### Administrative Committee for the TIR Convention, 1975

#### Revision of the Convention:

Accepted amendment proposals to the  
Convention pending formal adoption

## Accepted amendment proposals to the Convention pending formal adoption

Sketch No.10.2

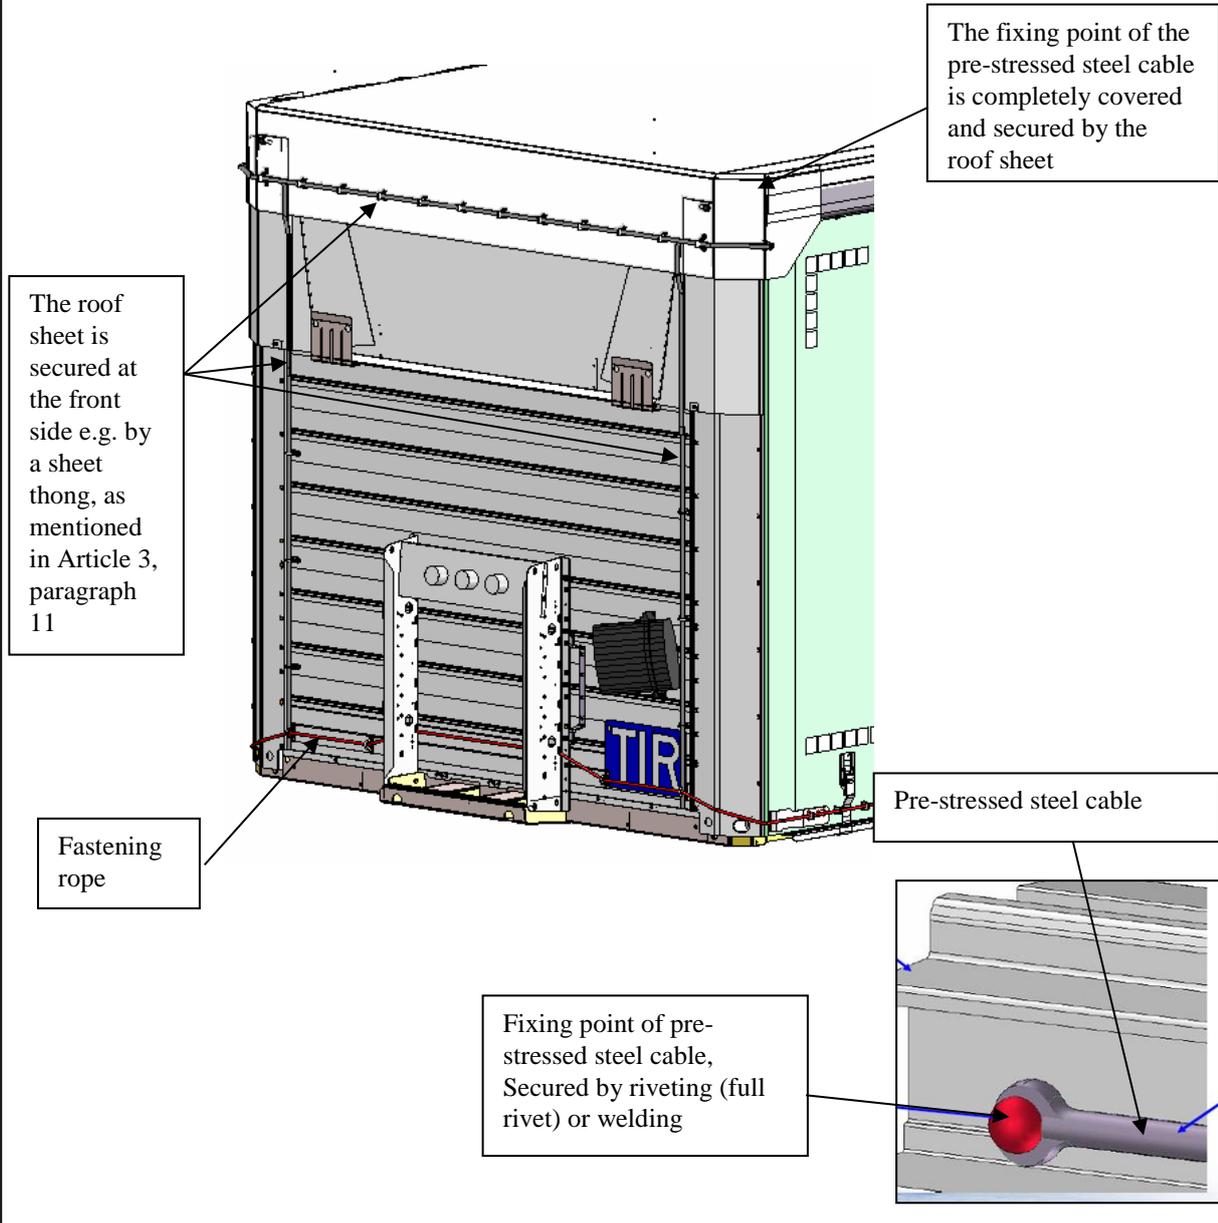
The sliding roof sheet shall overlap with the solid part of the roof at the front side of the container, so that the roof sheet cannot be pulled over the top edge of the upper cantrail
